**900 Thayer Avenue (Formerly "The Adele"),  
Project Plan Amendment 92005003A, Preliminary Plan Amendment 12005077A, Site Plan Amendment 82006020A**

**Completed: 5.20.13**

- Located in the southwest quadrant of the intersection of Fenton Street and Thayer Avenue, in the Fenton Village section of the Silver Spring CBD
- CBD-1/Fenton Village Overlay Zone, Silver Spring CBD Sector Plan, 0.96 acres
- Redesign the original project to 119,691 sf of mixed uses, including 124 du (incl. 12.5% MPDUs) and up to 5,300 sf. retail uses
- Redbrick Partners
- Submitted 3.4.13

- Staff recommends APPROVAL WITH CONDITIONS of the Project Plan Amendment, Preliminary Plan Amendment, and Site Plan Amendment
- The public use space and public amenity package raises concerns about conformance with the CBD-1 optional method requirements, portions of the Sector Plan, and compatibility with planned development in Fenton Village. Staff recommends conditions to address these concerns. The Applicant does not agree with all of the conditions.

*Proposed courtyard public use space*

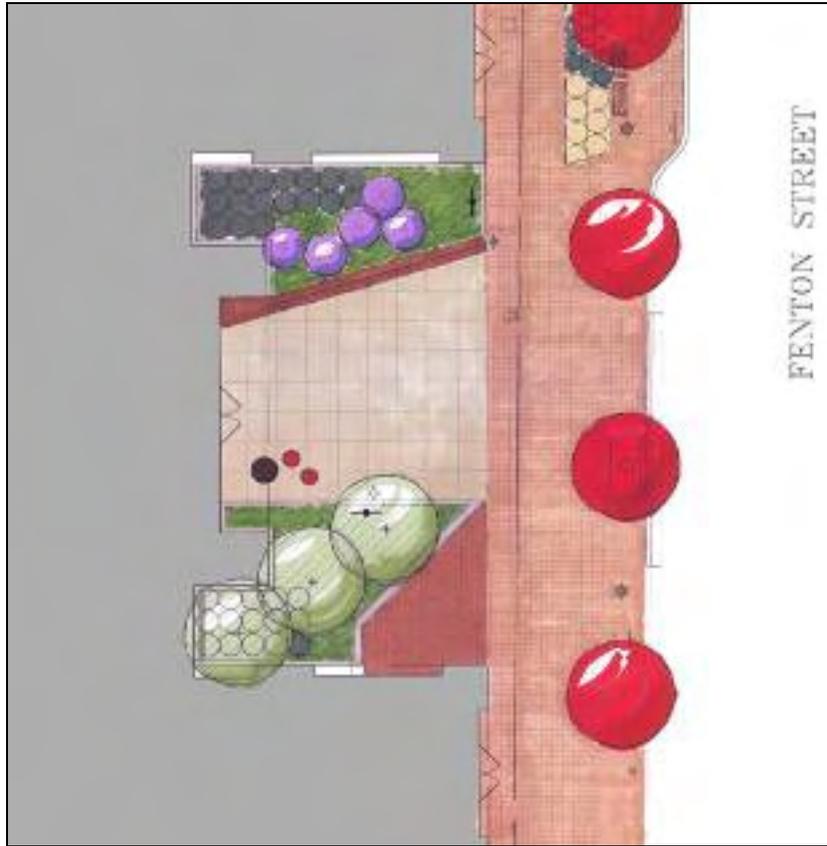
Second, the orientation of the seating in the proposed design does not maximize its focus on the public space. Of primary concern is the smaller seating area in the southeast corner of the courtyard. The use of a different surface material in such a small space and a seating wall that turns its back on the main space is related more to the adjoining retail entrance than the public space. In order to make sure that the courtyard public use space is as inviting as possible, staff recommends a condition that refocuses these areas on public use. First, on the southern portion of the courtyard the Applicant must reconfigure the stormwater planter and the related seating to orient more directly to the public use space and sidewalk (see illustration below). Second the Applicant must extend the bench on the northern side of the courtyard planter to face directly onto Fenton Street. These changes will provide immediate and welcoming access to the space from Fenton Street. Staff will continue to work with the Applicant to finalize the design details at Certified Site Plan.

- c. The Applicant must revise the design of the public use space as follows:
  - i. extend the angled bench on the northern micro-bioretenion planter box around the eastern edge of the planter box, along Fenton Street;

- ii. reconfigure the southern micro-bioretenion planter box to provide a seating wall, bench, or similar seating that directly faces both into the public use space and onto the Fenton Street sidewalk;

- iii. the final design must be approved by staff prior to Certified Site Plan.
- d. In lieu of providing the remaining 571 sf. (2 %) of on-site public use space required to meet the minimum requirement of 20% of the net lot area, the Applicant must contribute to M-NCPPC no less than \$54,215 for development of Gene Lynch Urban Park in the Silver Spring CBD, or other amenity designated by the Planning Board at the time of Project Plan review. The payment must be submitted to M-NCPPC prior to release of the first building permit.
